APPLICATION FOR PLANNING PERMIT : TP-2012-923
4 PRIDHAM STREET, KENSINGTON

4 June 2013

DELEGATED PLANNING APPLICATION REPORT

1 PROPOSED GROUND FLOOR PLAN

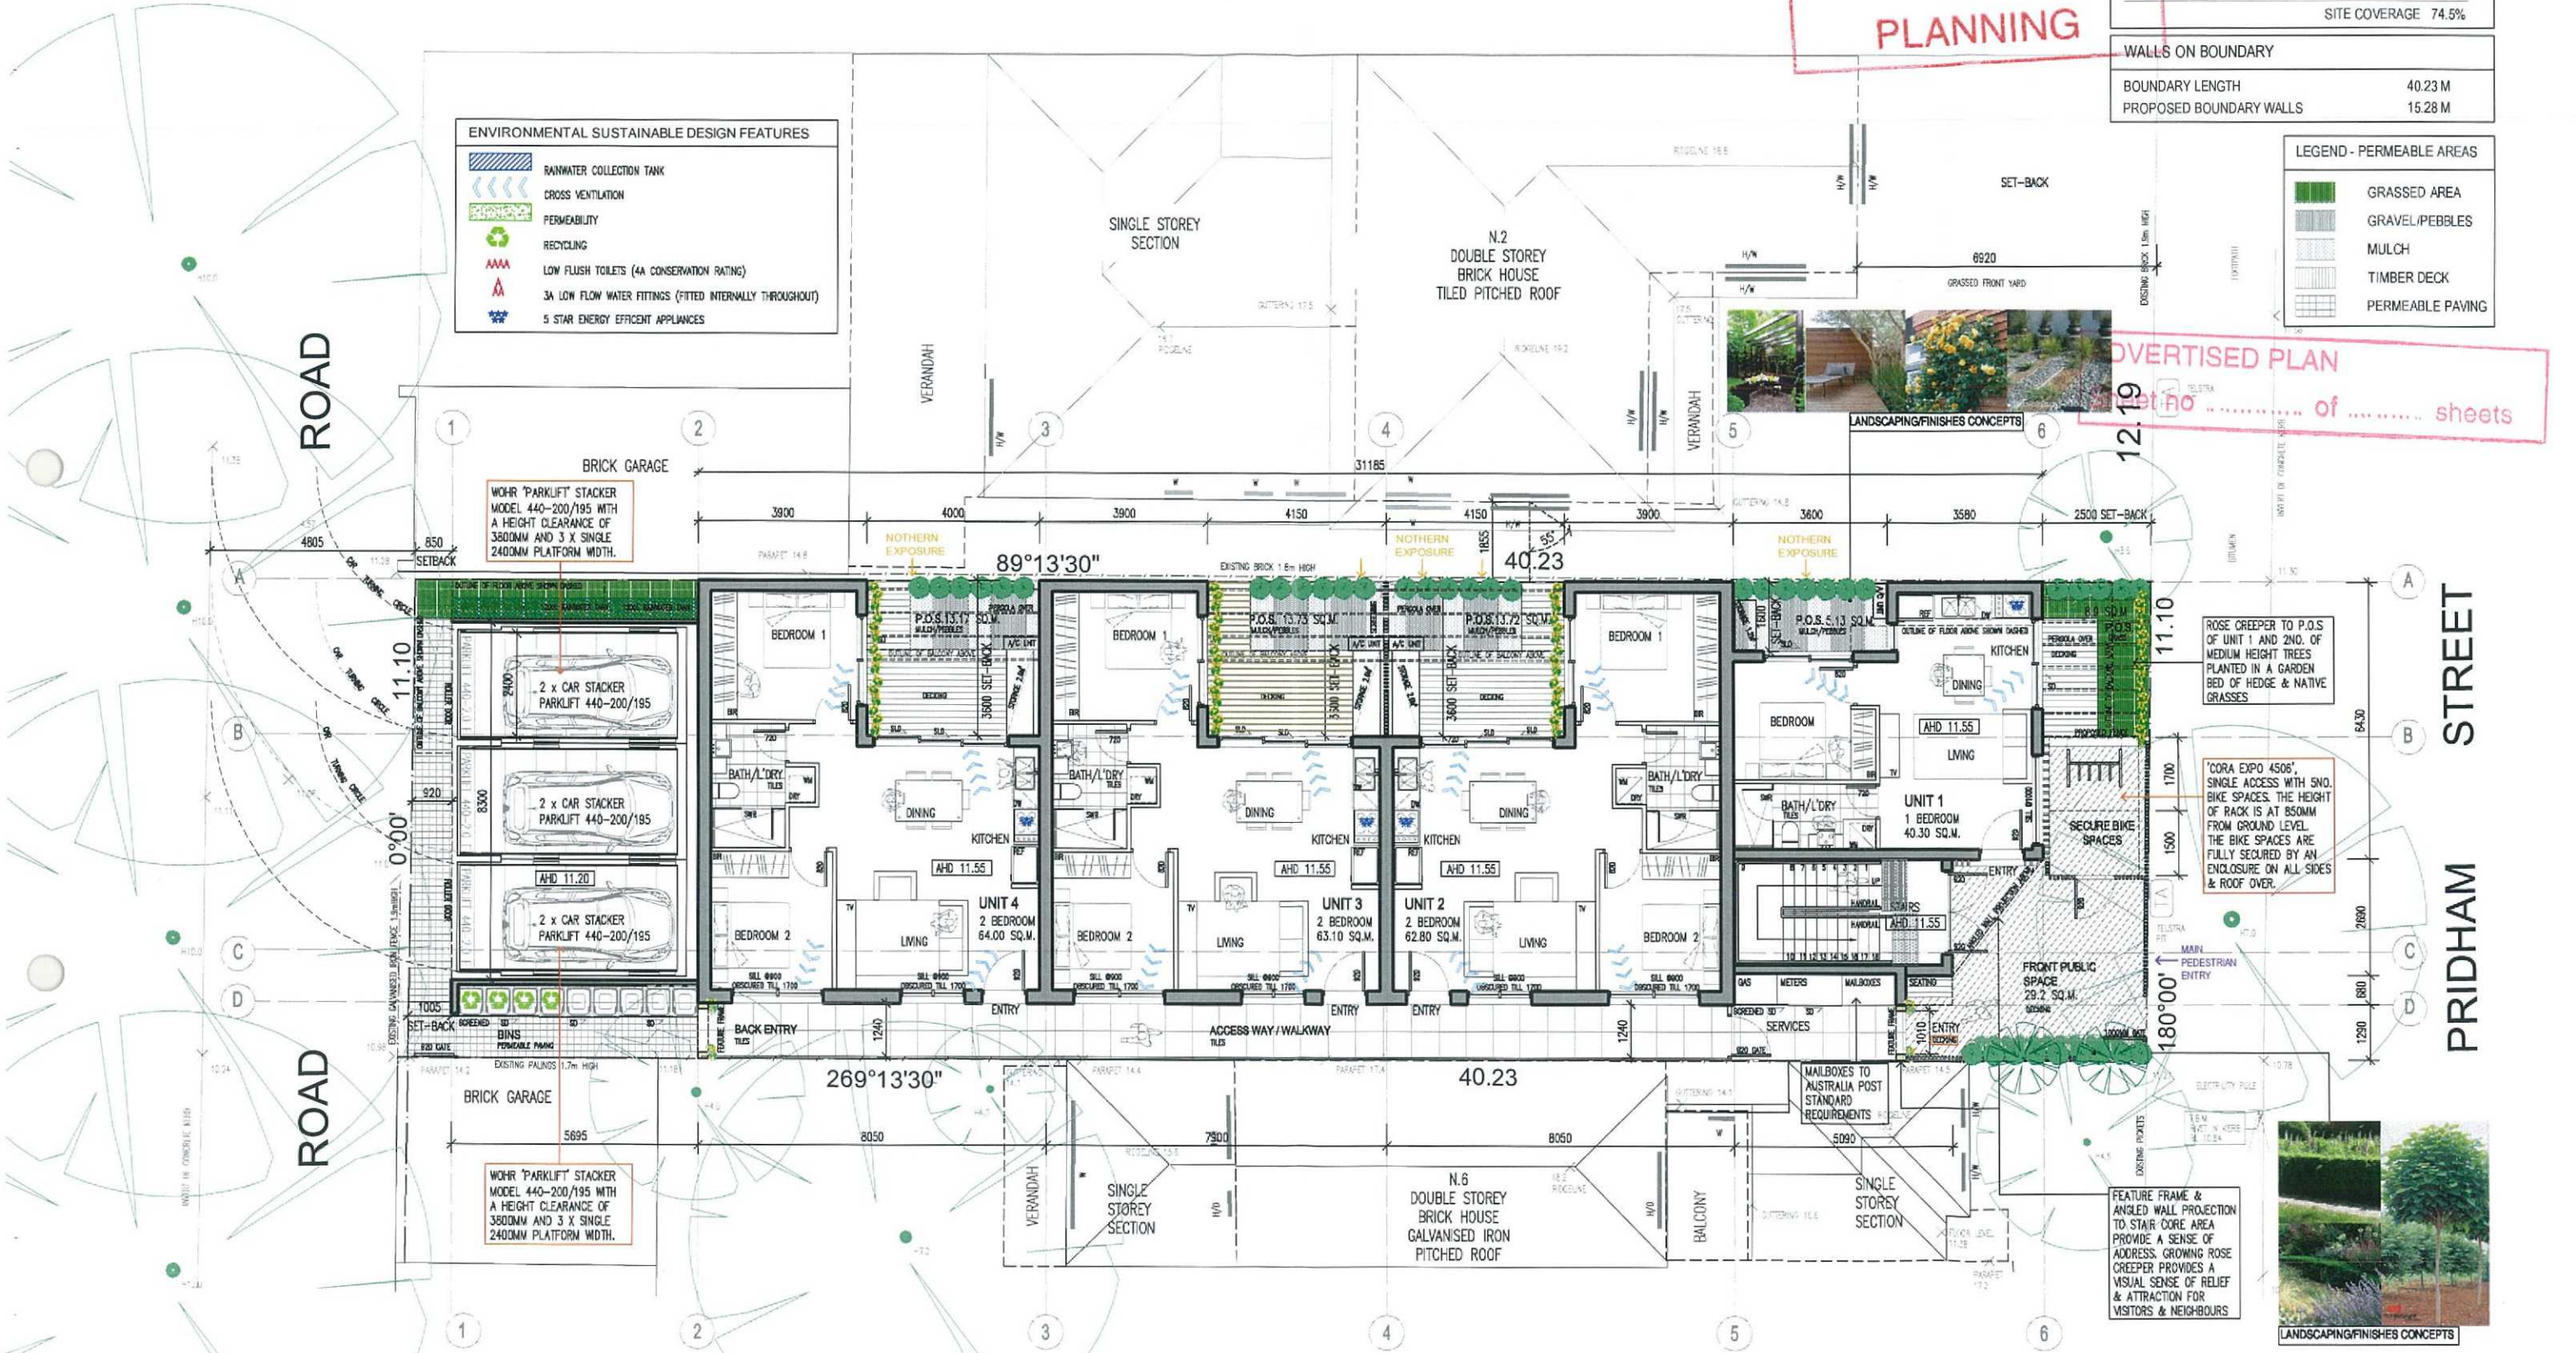
1. Plan TP06 shows that there is a 1:3 gradient from the property line to the garage roller doors. This gradient would result in scraping and is not acceptable. Car stacker manufacturers generally specify flat or near-flat areas on approach to car stackers. Changes to this aspect of the design could have implications for the height of the building.

2. Although the Planning Report states that spaces are 2.6m x 4.9m with a reversing dimension of 6.4 metres, this is not relevant to a car stacker proposal. Plan TP06 shows that the back out distance for the northern space is only 5.65 metres which is unlikely to be sufficient. The applicant should be required to obtain advice from the car stacker manufacturer in relation to the back out distance required, and appropriate amendments made to the plan. This should occur prior to any permit being issued in relation to the application as any required changes could have subsequent impact on other components of the building.

3. Plan TP06 also indicates that each car stacker unit is approximately 2.4 metres in width as each section is enclosed by a separating wall. Bearing in mind the narrow laneway width, it is considered that vehicles will have difficulty in accessing each car stacker unit. It is therefore requested that the applicant provide AutoTurn turning movement diagrams showing that each vehicle can enter/exit each stacker unit with relative ease.

According to the Planning Report it is proposed to provide a rack for 6 bicycles at the front of the site. However, Plan TP06 shows only 4 spaces.
